Docket Item # 13
BAR CASE # 2007-0233

BAR Meeting
December 6, 2007

ISSUE: Addition and alterations

LOCATION: 500 Jefferson Court

Figure 1: Proposed façade, west elevation

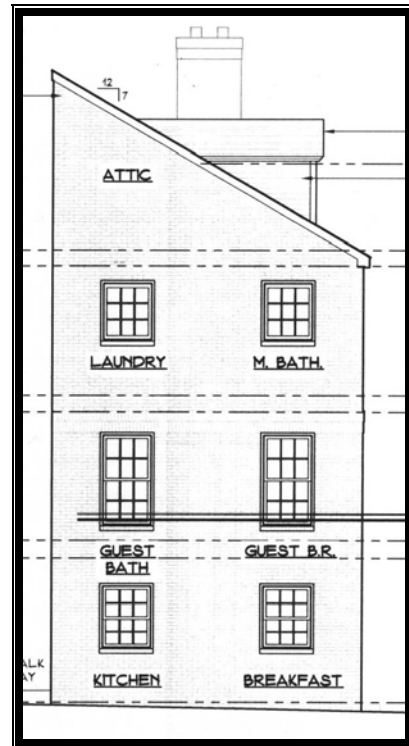
The new third story on the front (west) elevation facing Jefferson Court will have four windows aligned with those below. The nine-light windows will be casement, but will appear as double hung, and will have a recessed wood panel with a metal grill underneath each window. This window, like all the new windows, will be wood with simulated divided lights with wood muntins and a spacer bar, manufactured by Loewen. The windows will have a brick rowlock sill to match the existing. The roof slopes down toward the west. There will be three evenly spaced dormers in the roof. The dormers will be gabled and will have fixed six-light windows. They will have wood trim, Hardiplank horizontal siding with a 4” reveal and smooth finish on the sides and asphalt shingle roofs.

Staff has significant concerns regarding adding a third story plus attic to the existing two story house. The massing and form of the expanded building are at odds with the existing building and surroundings. While there are three and four story houses in the immediate area, the character of Jefferson Court is small scale and intimate. The houses within the court that were constructed circa 1966 as part of Jefferson Square Townhouses Section II, are mostly two, and no more than two-and-a-half, stories in height. The houses are in scale with the narrow court and reflect a traditional development pattern of larger buildings on the exterior of blocks and smaller structures on the interior. By increasing the height of the house at 500 Jefferson Court, the scale and cohesiveness of this small enclave will be altered and adjacent buildings will be overwhelmed. Secondly, the house itself will be negatively impacted. The proposed addition does not respect its original massing or form. It currently exhibits a Georgian or Georgian Revival sense of massing and harmonious proportions-- five bays wide, two bays deep and two stories high, under a low hip roof. The additional story and a half will create an awkward vertical mass. The proposed single slope roof oriented to the street is an unusual form. The flounder type roof is typically oriented with the long roofline parallel to the side property line rather than to the front. The flounder form as used here results in a four story solid (except for the existing hexagonal window at the second story) wall on the east property line. While this acts as the rear of this property, it is technically a side elevation that will be readily visible from Wilkes Street. Staff does appreciate that the architect has attempted to provide some relief for the sheer wall by inserting recessed brick panels on the third and fourth stories. The three and a half story end wall facing Wilkes Street will overwhelm the two story houses to the west. Similarly, the south end wall with its dramatic vertical bands of glazing will overwhelm the neighboring Jefferson Court houses. In the opinion of Staff, the proposed addition does not comply with the *Design Guidelines* that state that:

Therefore, Staff recommends that the application be deferred for reconsideration of the massing, height and form of the proposed addition. The applicant should know that Staff has strong reservations about any substantial change in the form or height of the existing building.

Figure 2: Proposed north elevation

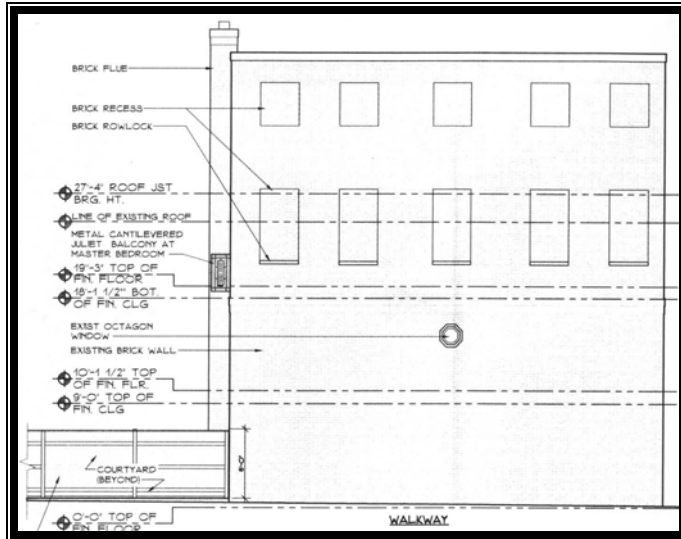
The north elevation, facing Wilkes Street, will have two windows in the third story that will be aligned over top of those below. These casement windows will have nine lights. There will be no openings in the fourth story. As noted above, the fourth story will be lighted by dormers on the west slope of the roof.

Figure 3: Proposed rear, east elevation

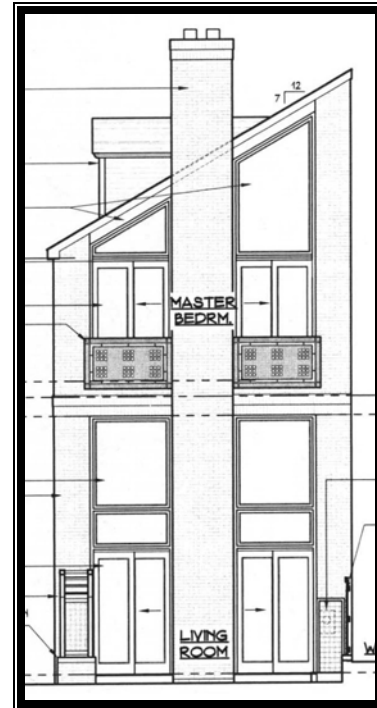
The full height of the addition will be seen on the rear (east) elevation. As it is located on the property line, there will be no openings in this elevation, in accordance with the building code. The applicant proposes that there be five evenly spaced, recessed brick panels with rowlock brick “sills” in the third and fourth stories.

- C-6 All exterior walls within 5 feet from an interior property line shall have a fire resistance rating of 1 hour, from both sides of the wall. As alternative, a 2 hour fire wall may be provided. This condition is also applicable to skylights within setback distance. Openings in exterior walls between 3 and 5 feet shall not exceed 25% of the area of the entire wall surface (This shall include bay windows). Openings shall not be permitted in exterior walls within 3 feet of an interior lot line.
